UDRP Report

110, 116 York Street

RE: Response to UDRP Recommendations – April 4, 2025
110, 116 York Street

Landscape Plan

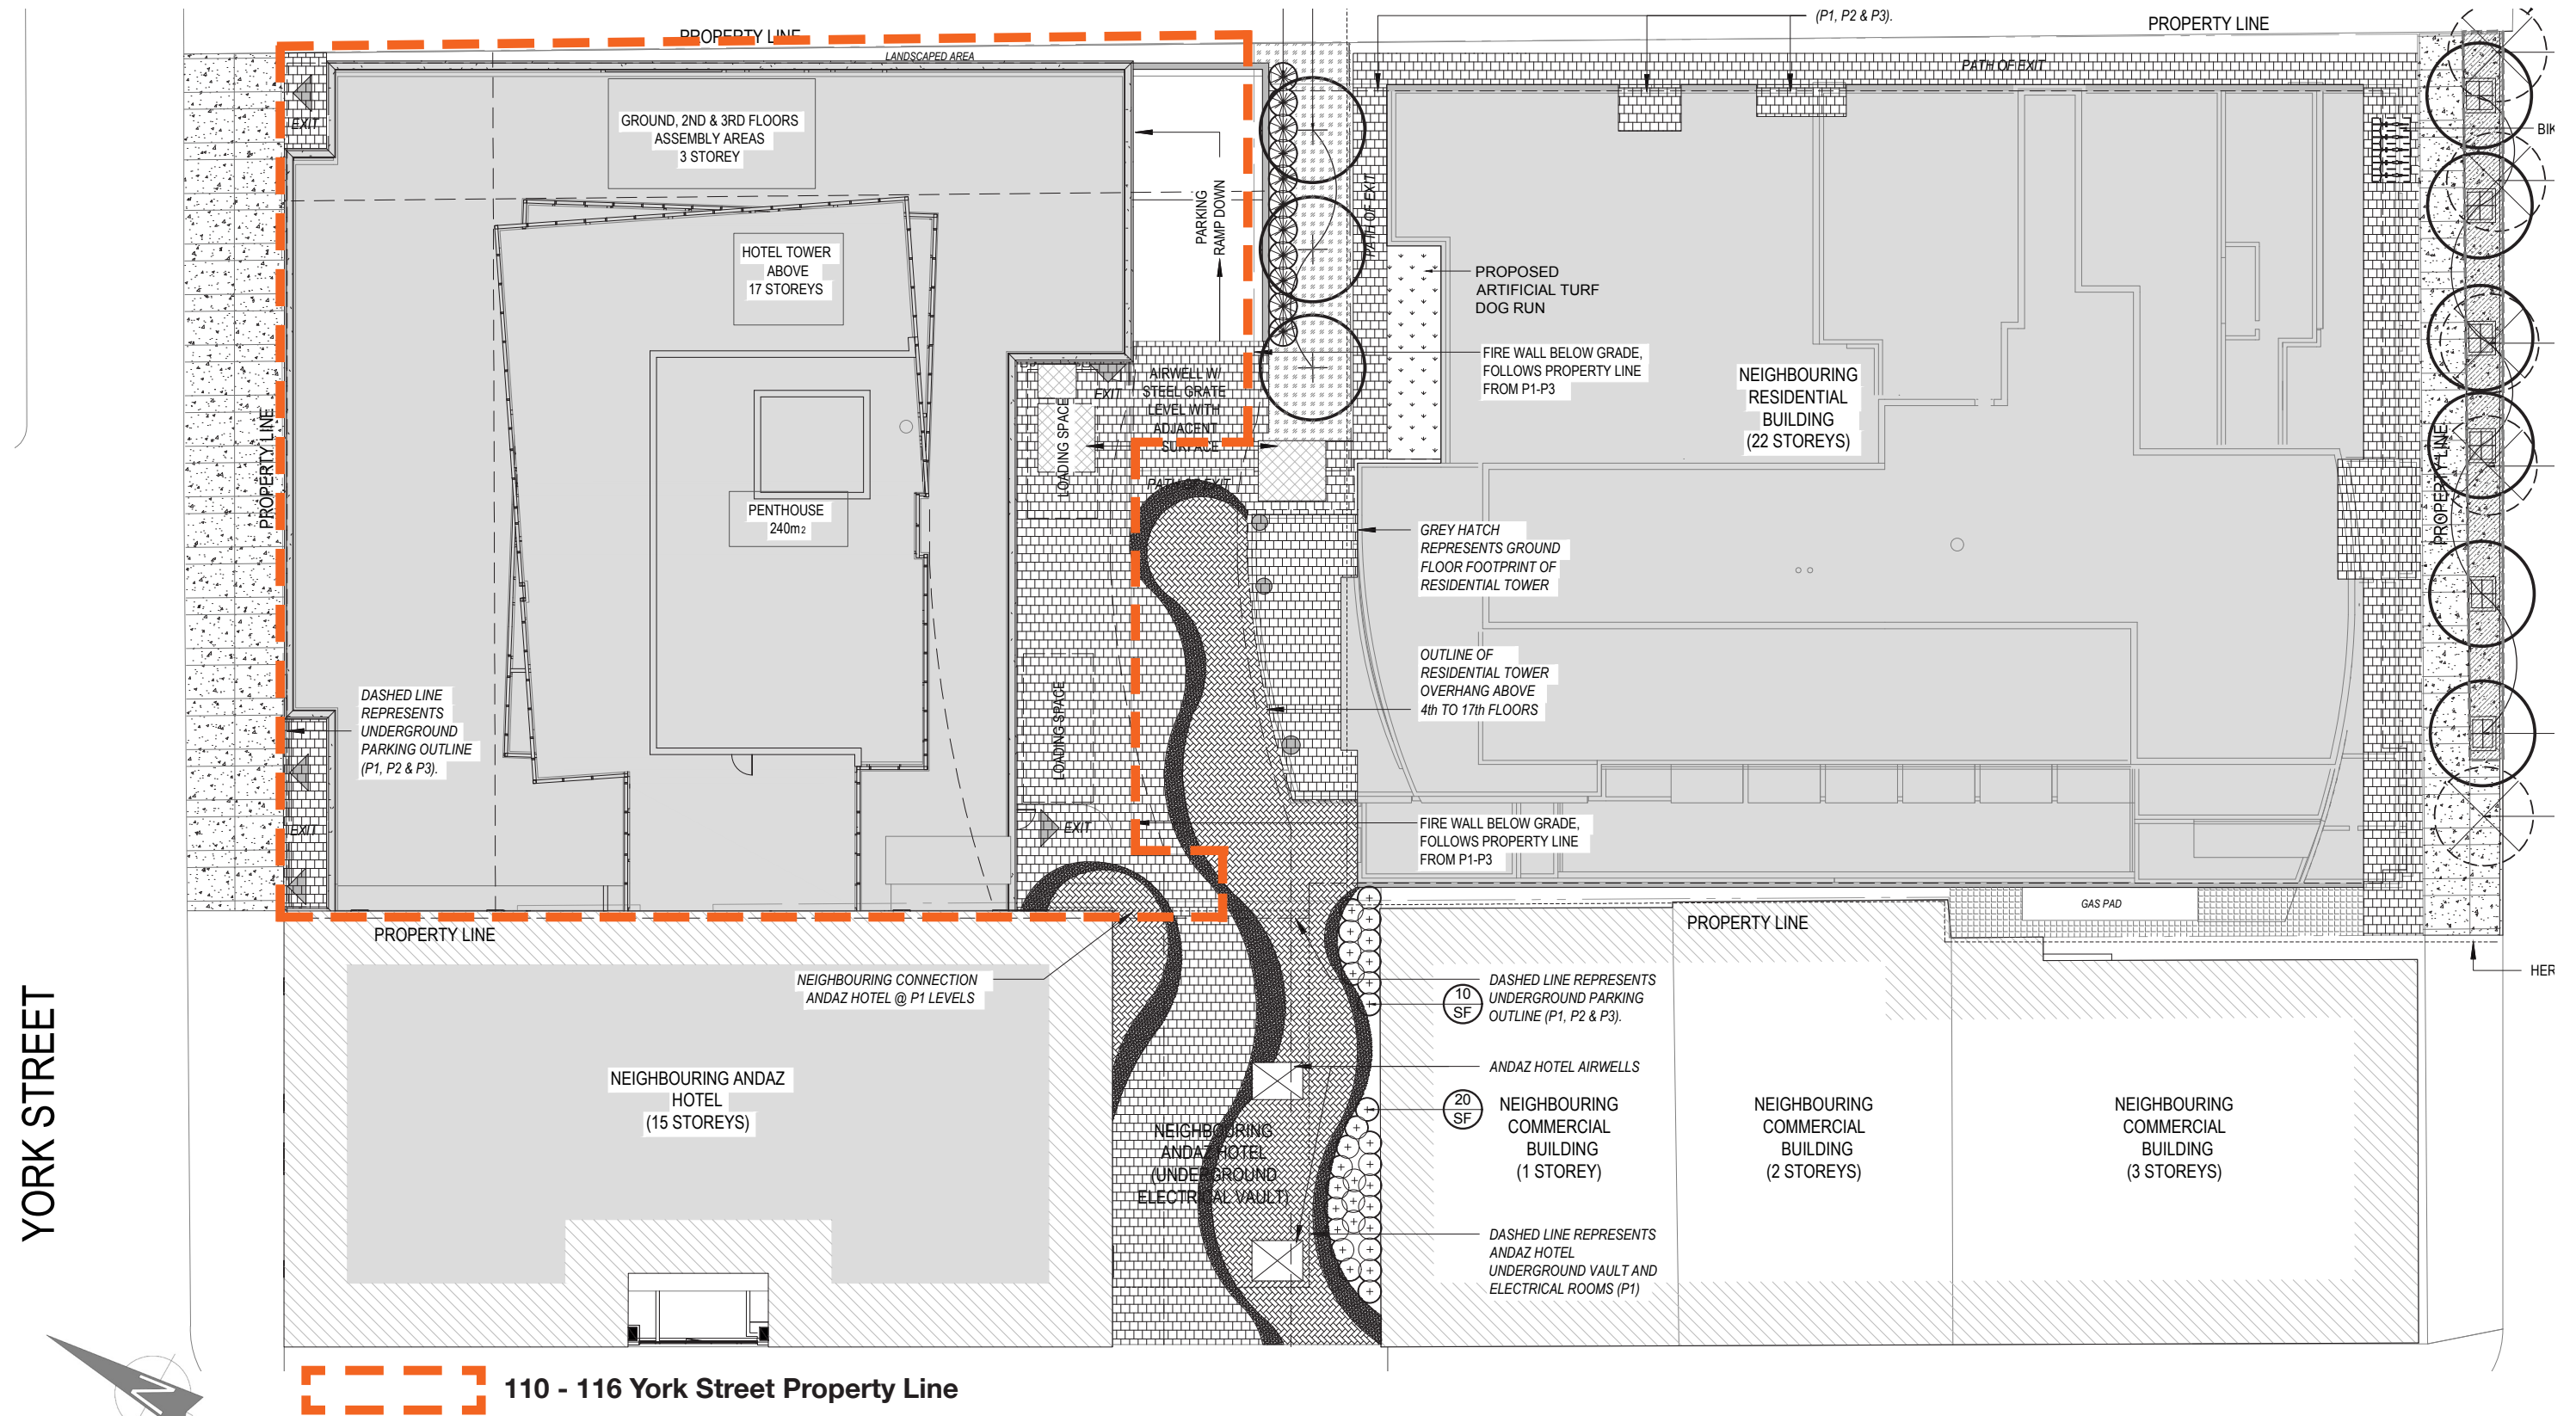
10. The Panel expresses concern with the laneway treatment at the rear of the site. While currently functioning as a service zone, the proposed paving patterns suggest pedestrian use that is unsupported by program, animation or safety measures.

/ The Panel suggests that the design intent should be clarified—either refine it as a high-quality service lane or transform it into a shared space that accommodates both people and vehicles with appropriate design cues.

/ The Panel suggests introducing additional soft landscaping, particularly within the courtyard and along the perimeter, to mitigate the urban heat island effect.

Response: Please refer to the response to Comment 4. The laneway is a high-quality service lane and access to the parking garage. Design elements are incorporated to make it visually appealing to residents and hotel guests in the surrounding buildings.

Response: The City requested vehicular access and traffic be removed from York Street, which required the hotel loading spaces and public parking access to be directed to the area between towers, reducing the ability to provide further soft landscaping. Light-coloured paving aids are proposed to mitigate urban heat island effect. Trees and shrubs are proposed within the courtyard and abutting the neighbouring commercial building on Dalhousie Street to screen the ramp to the parking garage and provide heat mitigation.

North Elevation

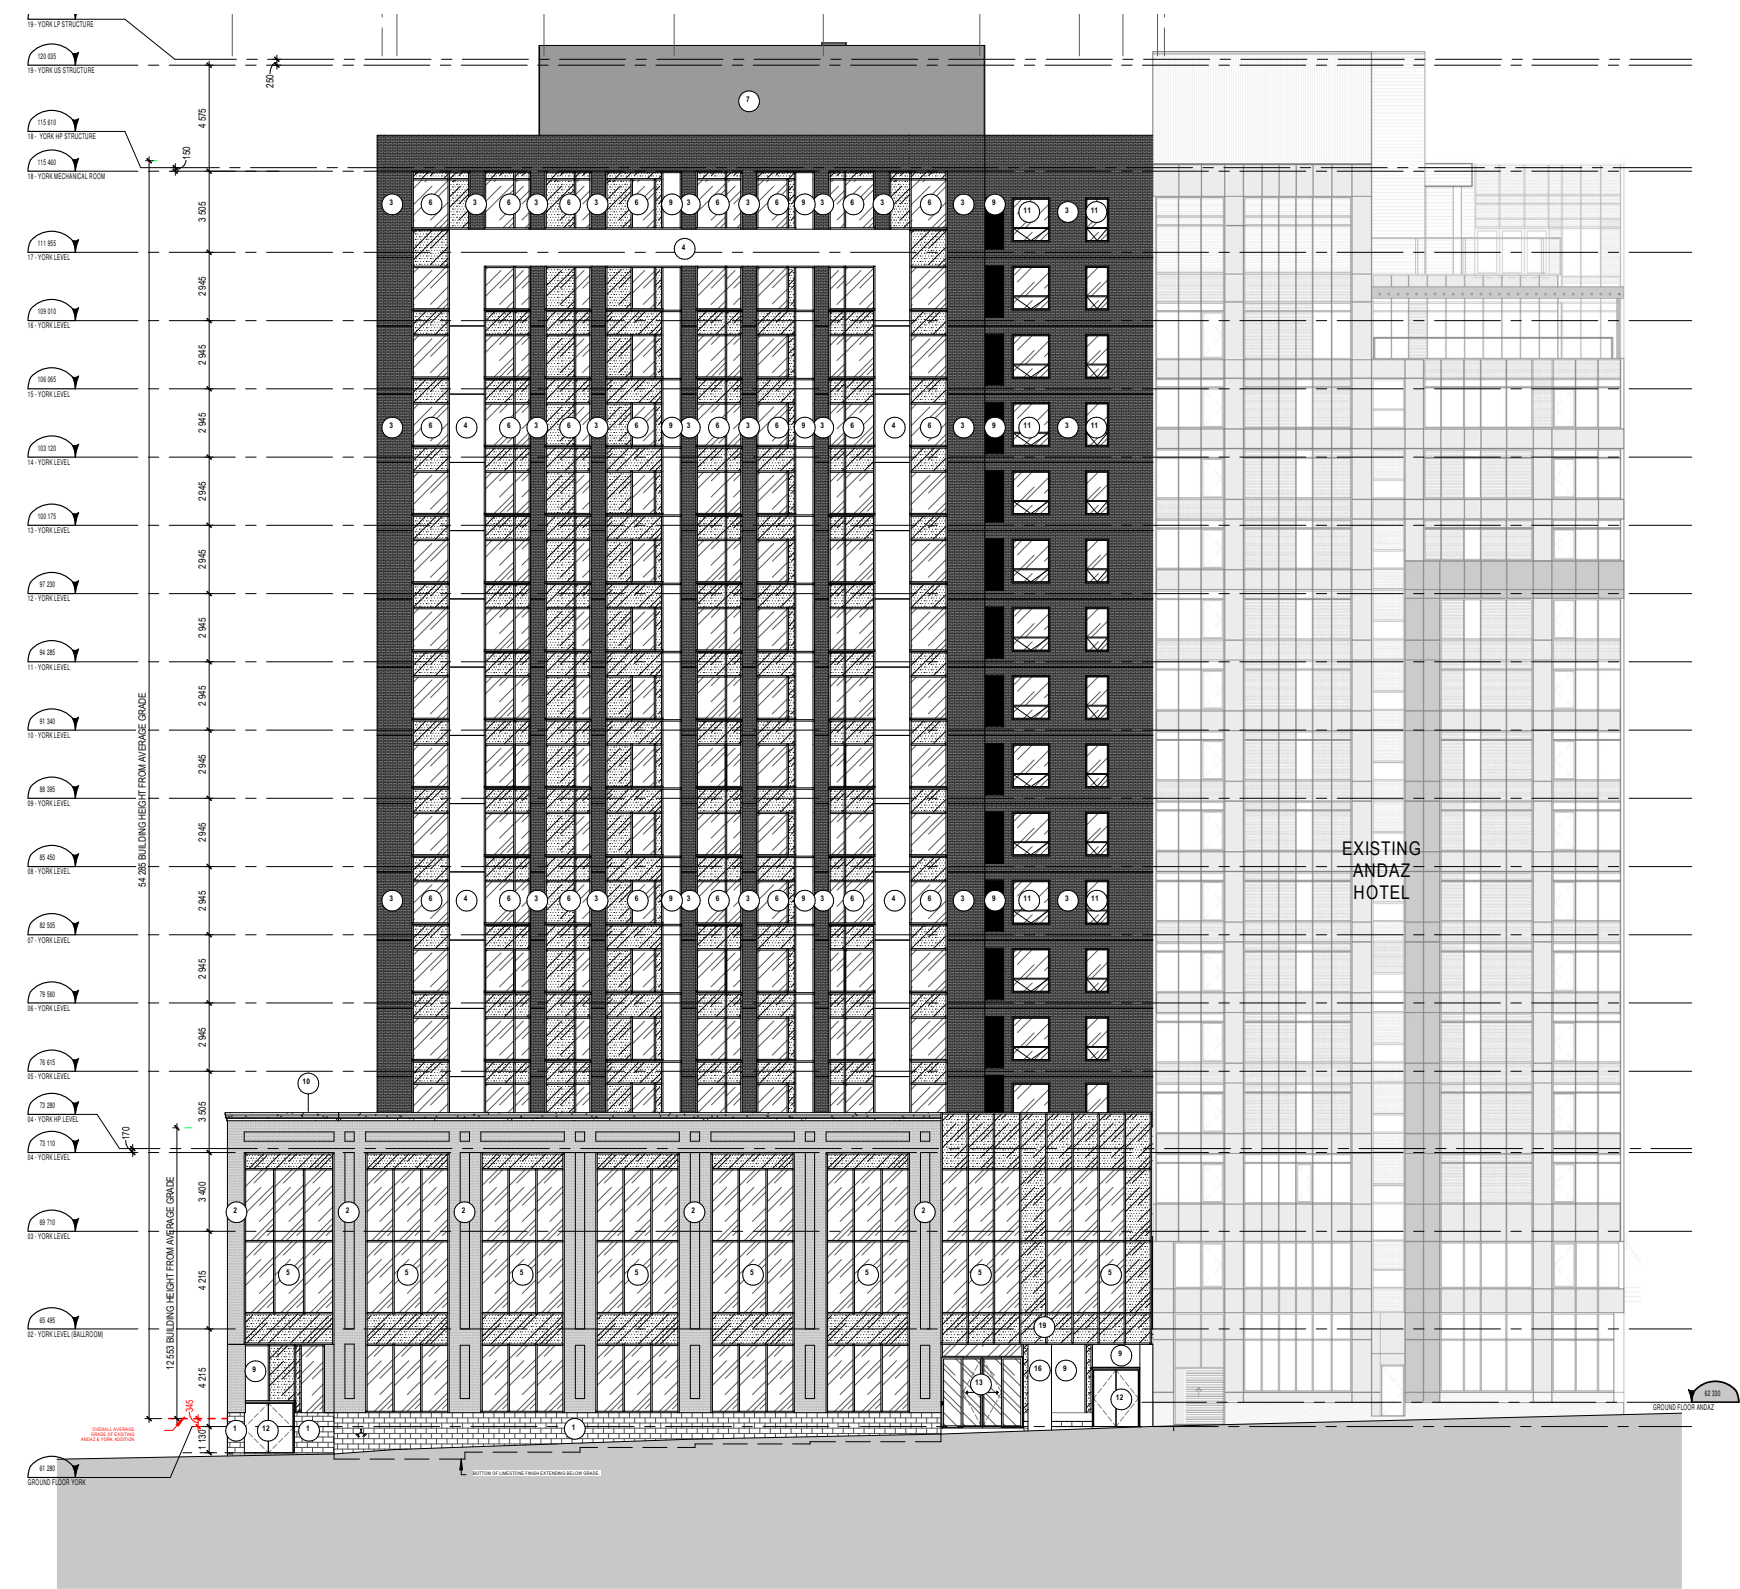
5. The Panel expresses general support for the materiality of the podium and initial design moves but identified issues with the flatness of the podium façade.

/ A higher quality, more articulated design and solidity is needed to align with the fine-grained texture of the surrounding neighborhood.

12. The Panel encourages stronger architectural articulation at both the podium and tower levels.

/ The current podium is perceived as overly flat and lacking the richness and solidity expected within a historic urban context. Greater detailing and modulation are recommended to better reflect the scale and texture of the surrounding buildings.

Response: In response to the Panel's feedback, recessed brick panels are proposed on the podium cladding, increasing the animation, light and shade of the building façade. The cornice on the top of the podium aligns with the design of buildings in the surrounding area.

Response: A decorative cornice is applied to the podium parapet and brick recesses around podium windows are shown on elevations. The glass volume over the main entrance will be recessed back to create variety between the existing Andaz and new brick podium facades.
